ROADWAY & INTERSECTION IMPROVEMENTS

FEDERAL PROJECT HSIP-2166(300)

DRAFT PDR PLANS
MAY 24, 2019

BANGOR
BROADWAY (ROUTE 15)

CROSSWALK STRIPING DETAIL

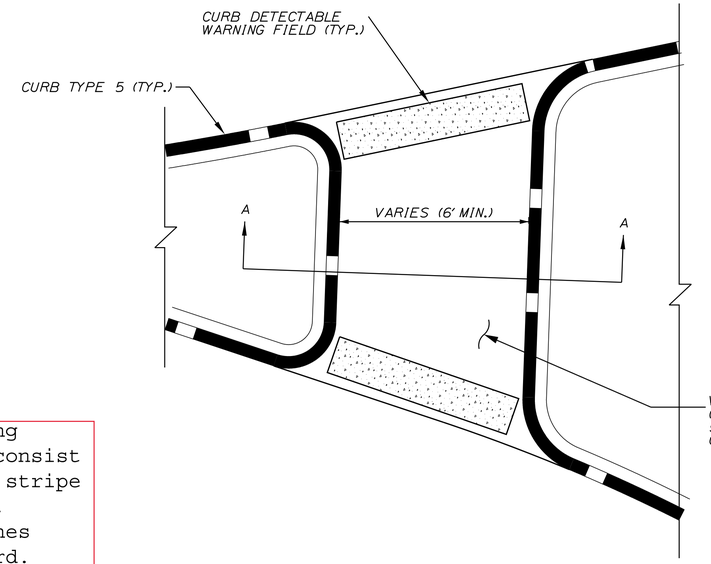
24"?

City striping appears to consist of 24" wide stripe and 12" gap. Design matches City standard.

STRIPING PLANS

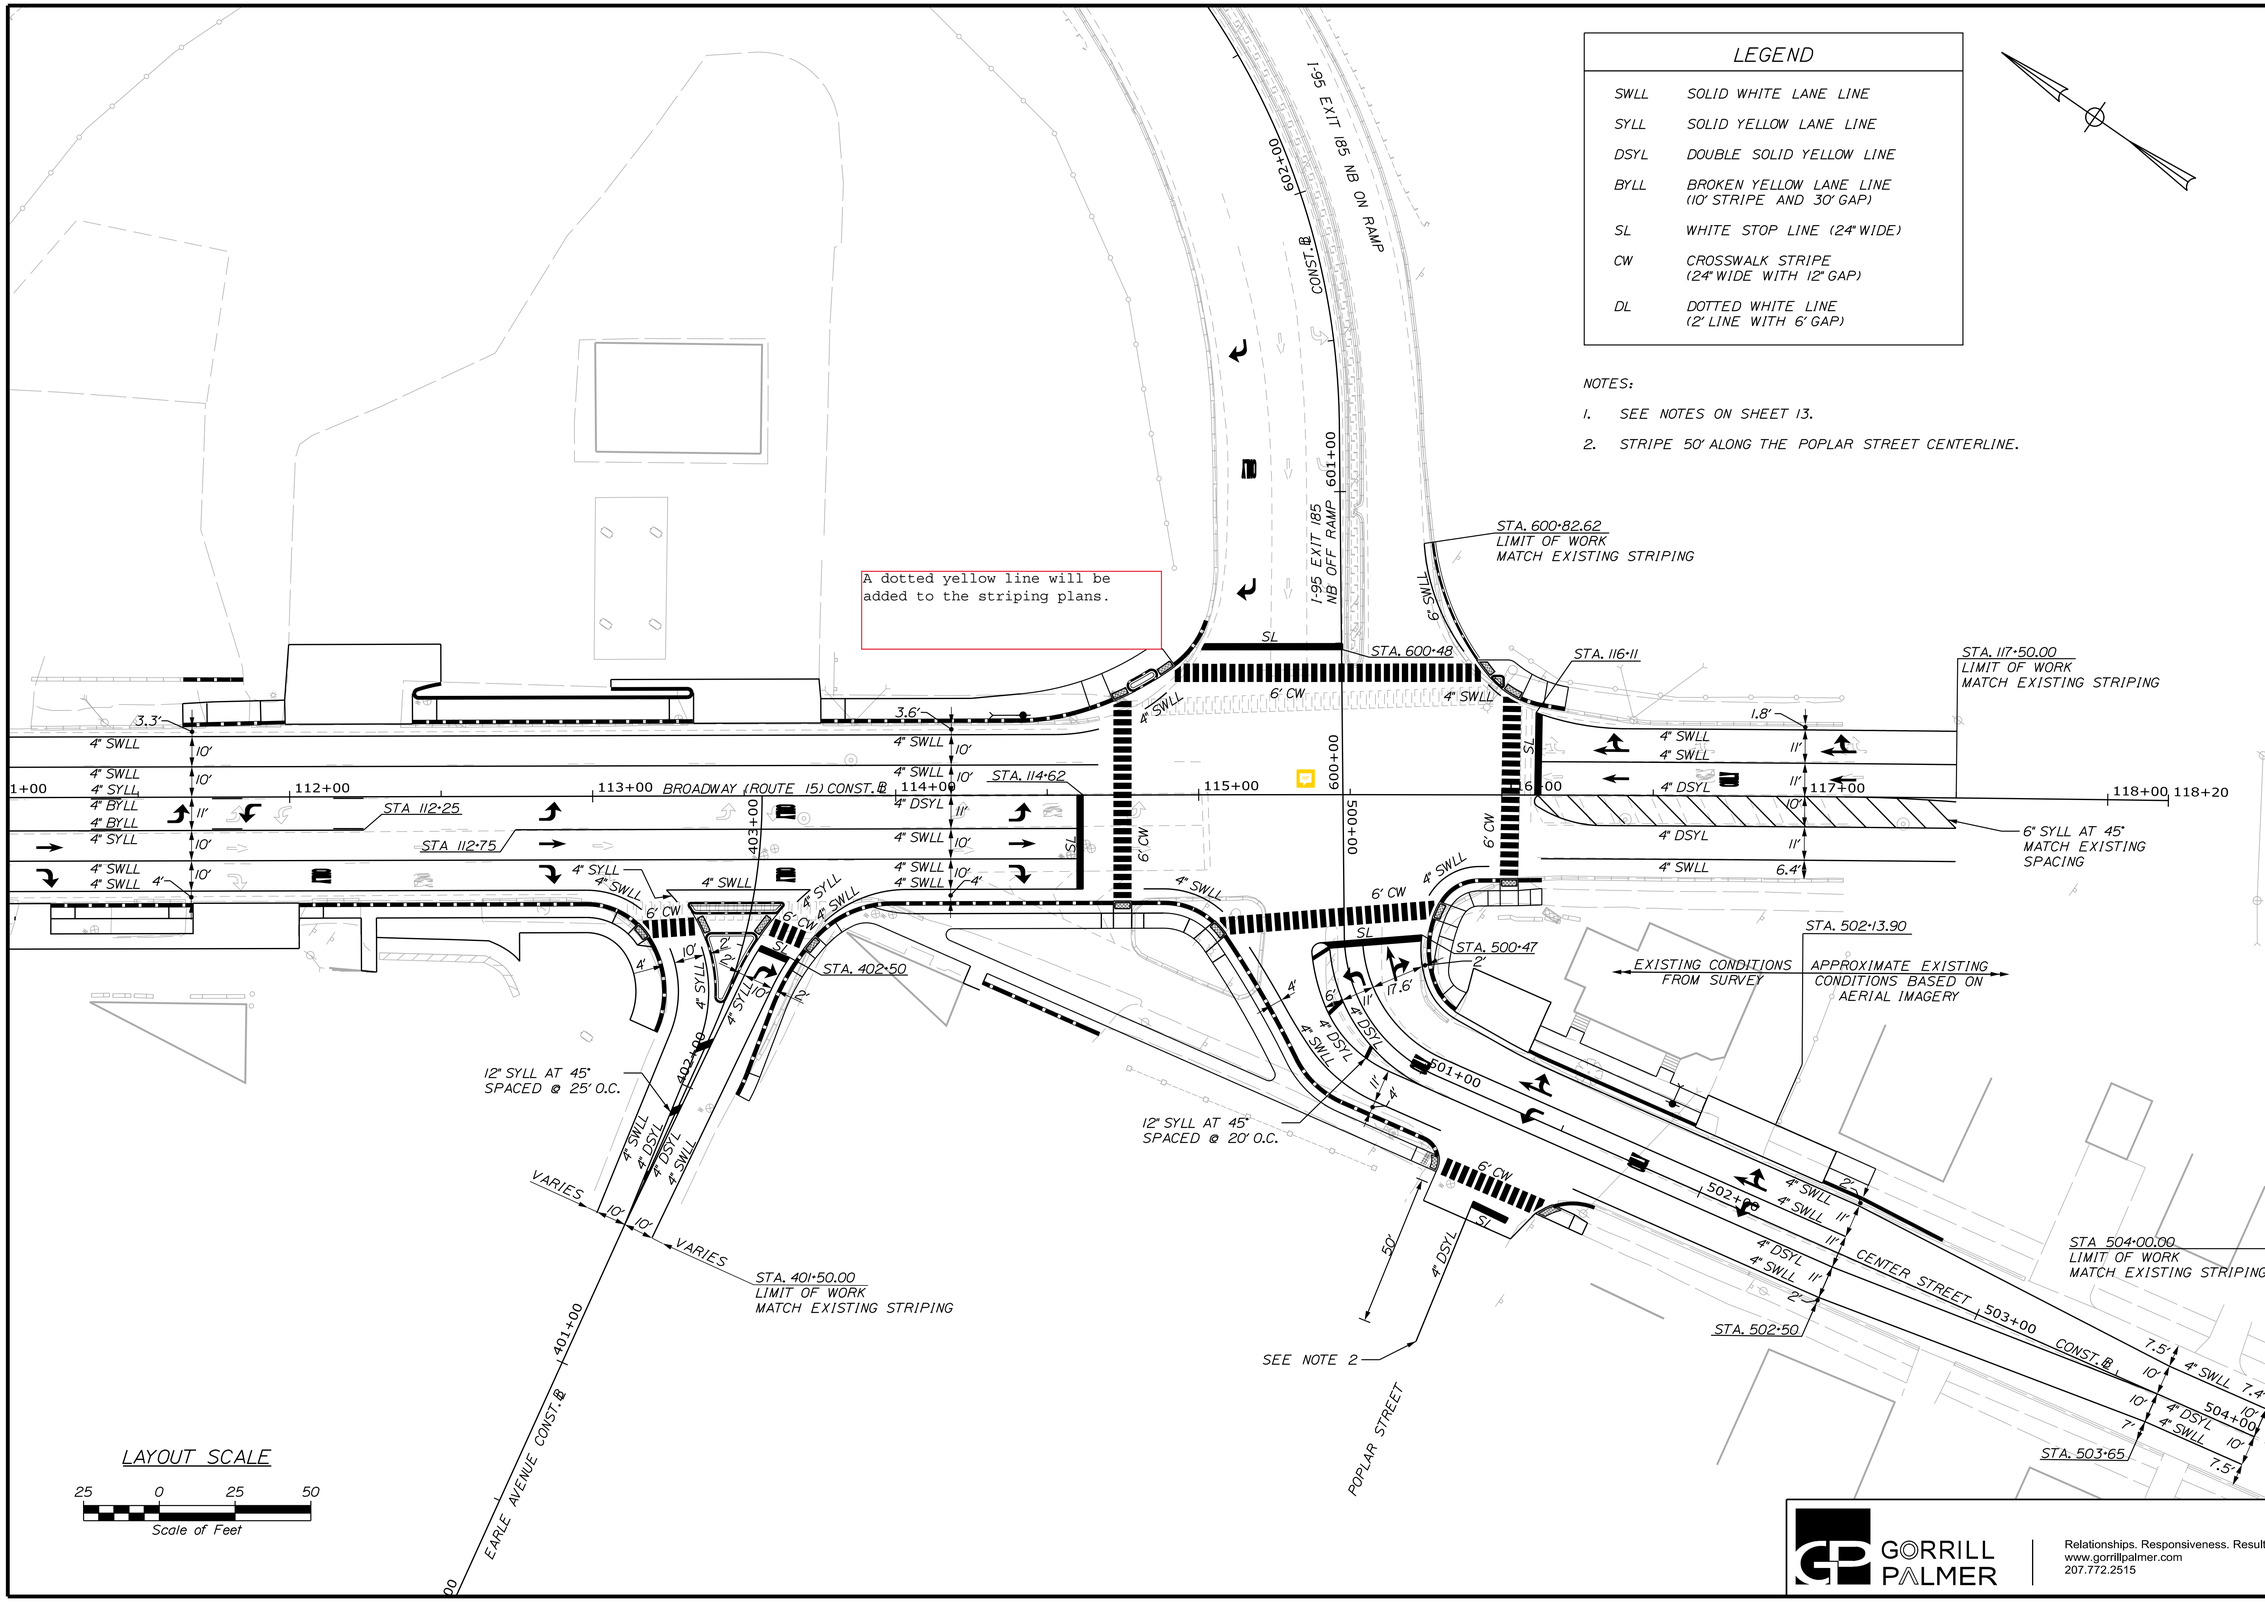
A dotted yellow line will be added to the striping plans.
